# DCD Design System: UI Kit Review

This review of the assembled components created for use in the DCD Design System is done from the perspective of an external designer/developer who would want to implement all or some of the components from the UI Kit. A great deal of high-quality work has gone into the components and documentation of the Design System. It is a comprehensive UI Kit that the DCD and its contributors can be proud of. Thanks to the talent and energy of multiple contributors, a professional-grade Design System is coming to fruition. Meanwhile, some unexpected dissonance permeates the technical structure of the vector files, the visual harmony, and overall visual consistency of the Design System UI Kit. By making suggestions that could clear up dissonance, this review aims to help the team achieve their goal of supplying a credible, world-class Design System that is comparable to the ones upheld as industry standard.

#### Button build structure

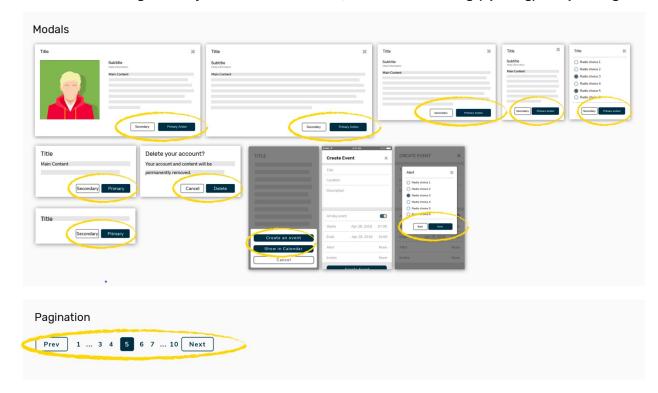
The vector structure of the buttons viewed in the UI Kit appear to be built in layers where the text is then placed 'by eye', left justified in its own layer. As a design draft, this technique is acceptable. However, this technique can create inconsistencies, leaving button shape size and text placement open to interpretation or error when being transferred into a new composition.

- Recommend converting buttons to shaped text boxes. A step-by-step tutorial can be provided.
- OR- Recommend converting button text to outlines and locking the two layers together as a group in final art

# Scale of components

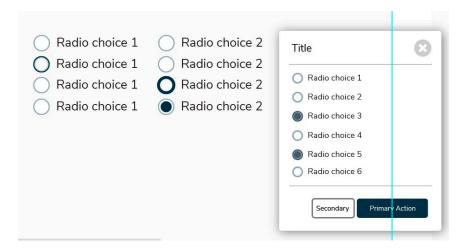
Some components are not designed to the same scale as others, which could be confusing

Image below illustrates the original design of radio buttons, and then scaled down versions of all buttons for a modal design. Ideally, the scale for the modal design incorporates the default scale of the buttons used.

o Recommend the same scale used throughout.

#### **Avatars**

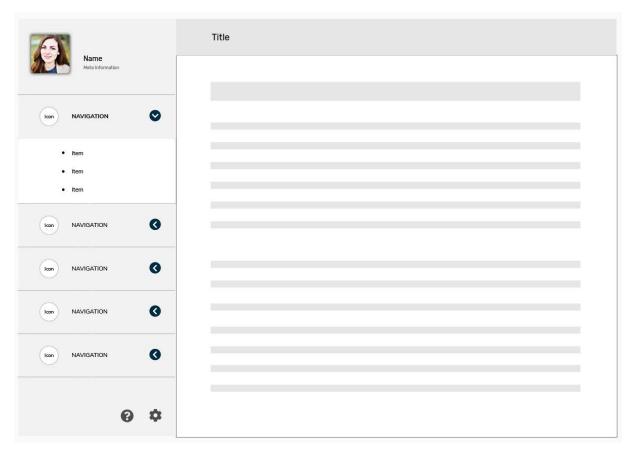
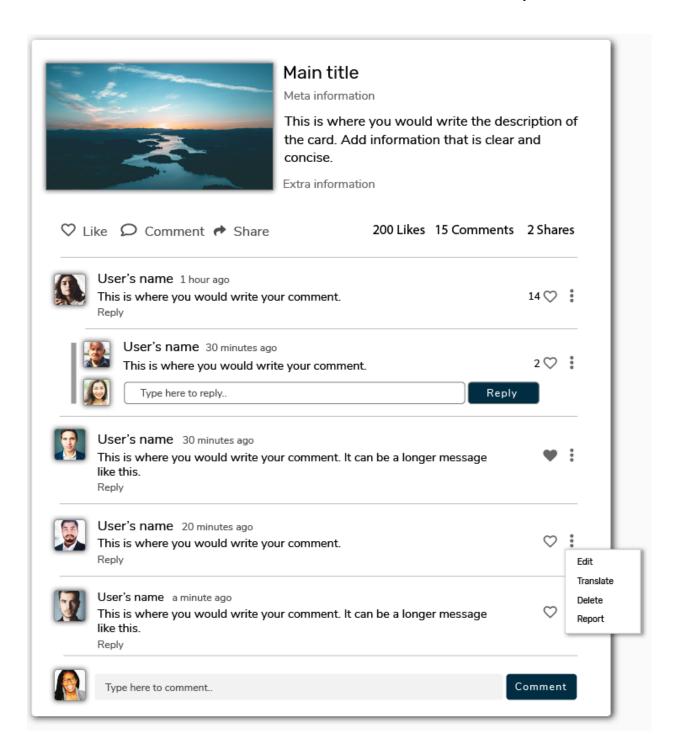
Some Design System themes uses real people. Example Bootstrap 'Pipeline' Components for sale: (http://themes.getbootstrap.com/preview/?theme\_id=4974&show\_new=)

With embedded images of real people in the UI Kit, an external designer can add more credibility to a composition. Grabbing a component where (Modal, Drawer) that includes a real embedded image at a pre-determined size would help an external designer to quickly convey a more realistic user interface. The addition of some layer effects might also enhance vibrance and visibility of images and avatars.

## **Mood Board Review and Recommendations**

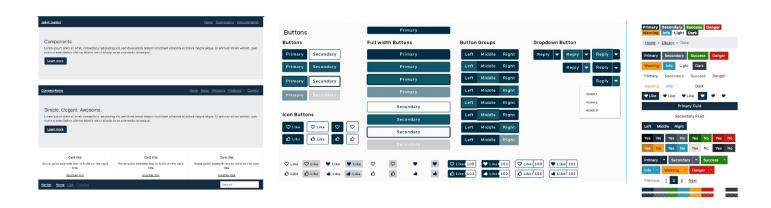
Thunder and Lightning appears to be the dominant palette in use
 Thunder and Lightning appears to be used as the main palette for the Design System
 <a href="https://gctools-outilsgc.gitbook.io/-gcdigital-design-system/colour">https://gctools-outilsgc.gitbook.io/-gcdigital-design-system/colour</a>. It is understood there is sound reasoning for this, such as accessibility and cross platform compatibility and the palette seems to be derived from Moodboard 1.

However, the holistic effect of using Thunder and Lightning moves away from the undocumented mandate for the Design System to be vibrant and cheerful, yet professional. The effect of using Thunder and Lightning is true to its name; an overcast day where the clouds are low, the waterfront is a dark blue and occasionally there is a sliver of sunlight breaking through the clouds. (Kind of like living in Vancouver).

Recommend considering Mood Board Heatmap results data which also supports the
possibility of a dominant palette based on MoodBoard 3, such as Blue Complimentary,
followed by Aurora Borealis as a secondary palette.
